DOE/EA-1574

Environmental Assessment for U-233 Stabilization, and Building 3019 Complex Shutdown at the Oak Ridge National Laboratory Oak Ridge, Tennessee

U. S. Department of Energy
Oak Ridge Office
Oak Ridge, Tennessee

March 2007

Figure 1.2, Building 3019 Complex

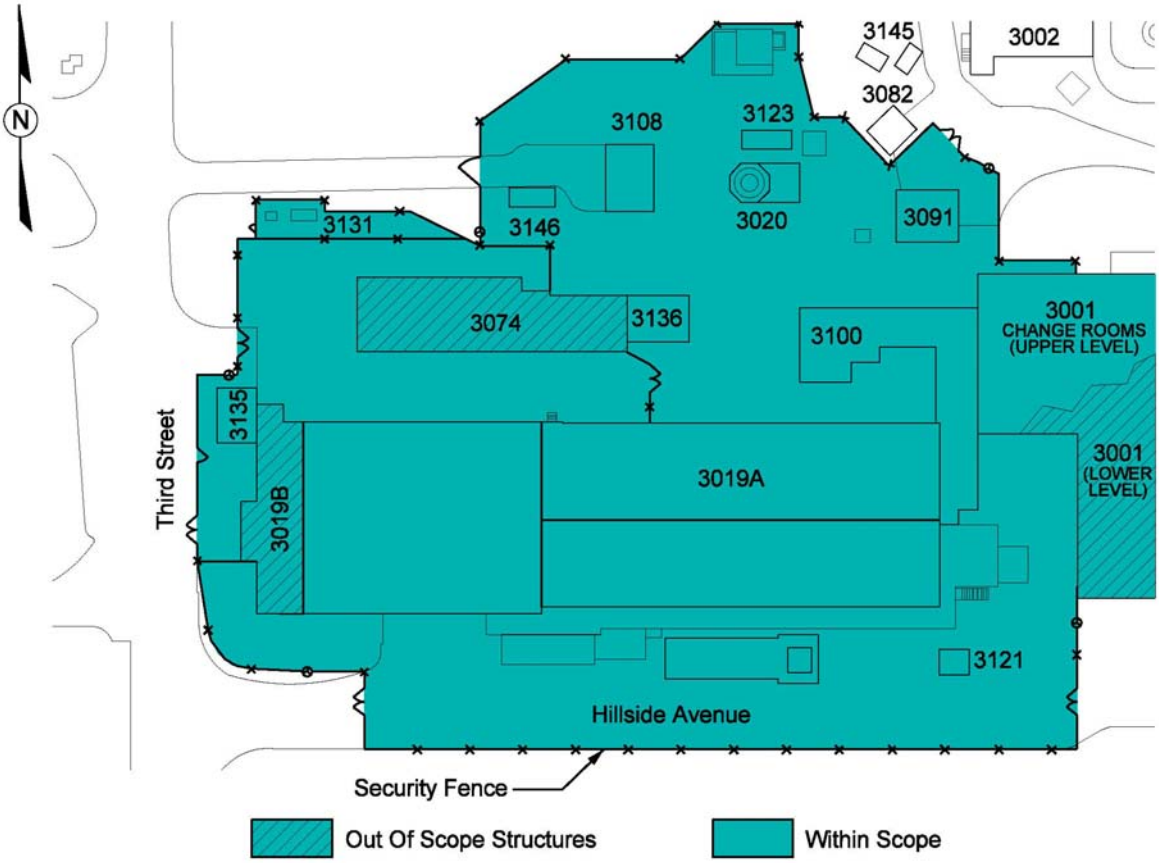
37.	<u>Page-7. Figure 1.3 Building 3019 Complex, Last Bullet, Tank P-24</u>: Where is the location of Tank P-24, and what is the concentration of U-233 stored in the solution?	Tank P-24 is located adjacent to Building 3019. The concentration is less than 0.007 g/L.

61.	Figure 1.3 is difficult to read in the black and white copy of the EA. Lighter shading should be used.	Figures have been appropriately deleted, added and amended based on final revisions of the EA.

Figure 2.1, Alpha activity and gamma exposure rate at 1 ft as a function of time calculated for 1 kg ^{233}U (with 100 ppm ^{232}U) as a loose-pour powder (1.5 g/cm2) contained in a 3-in. dia. by 6-in. tall can with 20-mil thick steel walls. ORNL/TM-13517

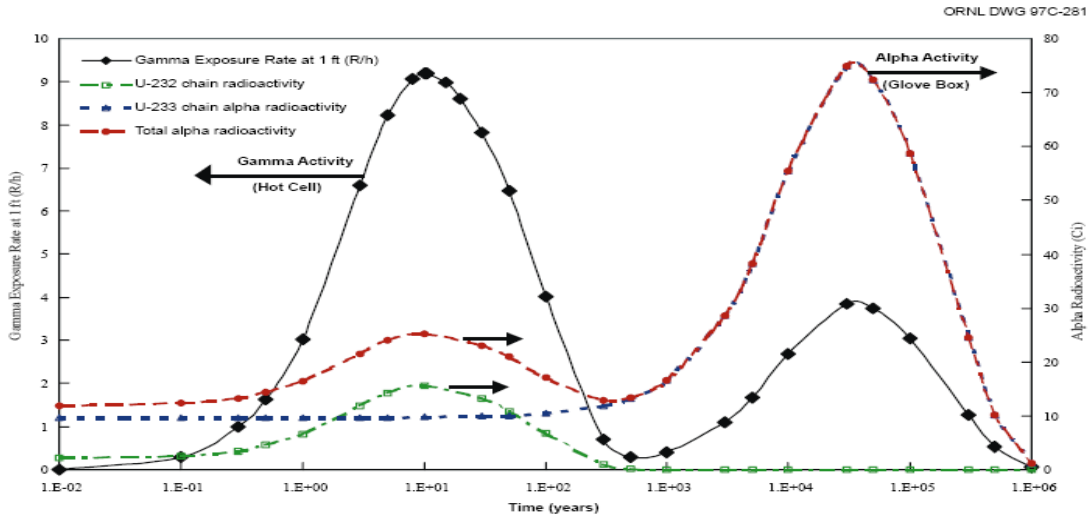
65.	The caption and axes labels on Figure 2.2 are too small to read.	Figure 2.2 and its caption have been excerpted from an external source. Efforts have been made to attempt to enlarge this graphic and correct the caption to read "(with 100 ppm ^{232}U)"

Figure 2.2 Conceptual ^{233}U Downblending

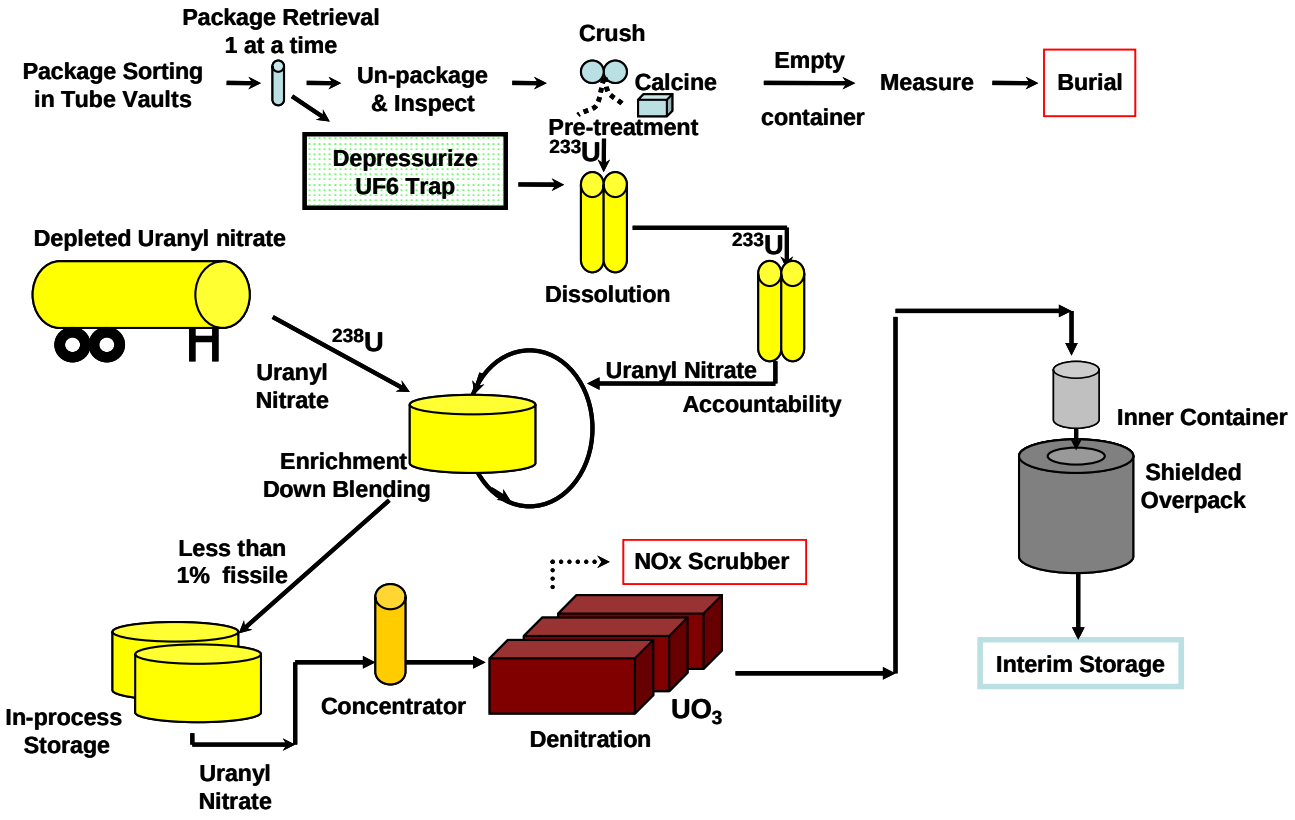
38.	Page 11, Figure 2.1 Conceptual ^{233}U Downblending, Last Sentence of the Paragraph; states that "....the *solution (uranyl nitrate) would be transferred from the tanker truck to a tank external to the Building 3019 Complex."* No description of this tank is given in the document. Is it an existing tank? Is it a new tank? What is/will it be made of? Will there be secondary containment? Is this an underground or aboveground tank? This type of descriptive information is relevant to environmental aspects of this document.	The uranyl nitrate will be transferred into an existing Tank P-23. The stainless steel tank is located in a pit surrounded by concrete shielding adjacent to Building 3019. The EA has been modified as follows: Section 2.1.4, 2nd paragraph , "to a tank" was clarified to refer to *"Tank P-23"* Section 2.1.4, the following text was added to the end of the page: *"Tank P-23 is an existing 10,000 gallon stainless steel tank located adjacent to Building 3019A in a concrete bunker. The bunker is partially below ground and partially above ground and is accessible by removing concrete shield hatches. In the event of a leak, the bunker would serve as secondary containment. The bunker is equipped with a sump pump should the need arise to pump the pit. The tank will be equipped with a high level alarm and the sump shall also be alarmed."*

39.	Page 11, Figure 2.1 Conceptual ^{233}U Downblending: The figure indicates that the empty ^{233}U containers will go to burial. Where exactly are these planned for disposition?	Based on past practice and waste characterization data DOE expects that the empty ^{233}U containers will be disposed of off-site as LLW. The Department will confirm this by characterization once containers are empty and prior to disposal.
